Proposed Addendum r to Standard 189.1-2023

Standard for the Design of High-Performance Green Buildings Except Low-Rise Residential Buildings

First Public Review (September 2025)
(Draft Shows Proposed Changes to Current Standard)

Addendum r to 189.1-2023

Figure 7.6.2.1(b) Map of Six Regions for Natural Gas Delivery.

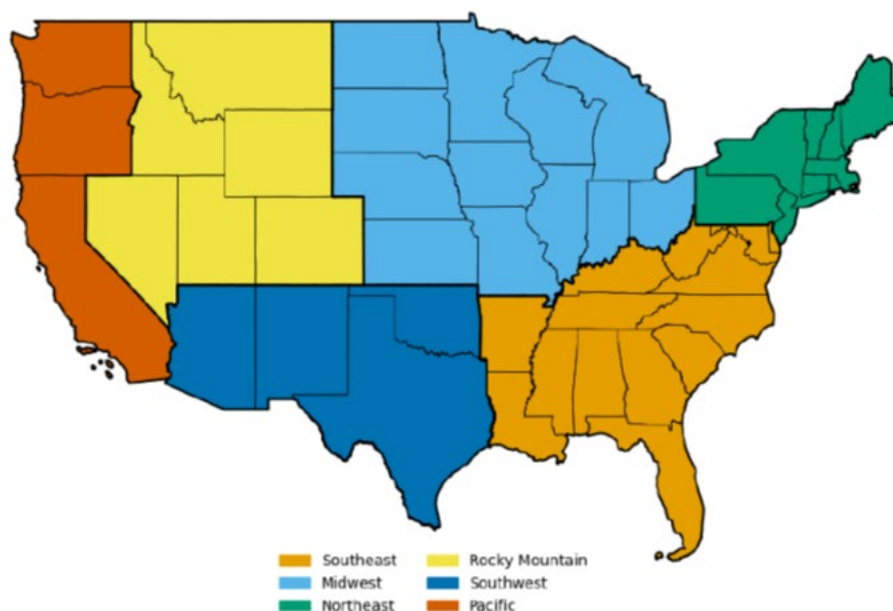
Modify Section 7.6.2.1 and Table 7.6.2.1 and Insert new Figure 7.6.2.1(b)

| CO ₂ e Emissions (kg/MWh) | | | | |
|---|--------------------------|------------|----------------|-------------|
| <u>Natural gas</u> | <u>Midwest</u> | <u>184</u> | <u>59</u> | <u>243</u> |
| | <u>Northeast</u> | <u>184</u> | <u>44</u> | <u>228</u> |
| | <u>Pacific</u> | <u>184</u> | <u>69</u> | <u>253</u> |
| | <u>Rocky Mtn.</u> | <u>184</u> | <u>68</u> | <u>252</u> |
| | <u>Southeast</u> | <u>184</u> | <u>70</u> | <u>254</u> |
| | <u>Southwest</u> | <u>184</u> | <u>65</u> | <u>249</u> |
| | <u>Other²</u> | <u>184</u> | <u>52</u> | <u>236</u> |
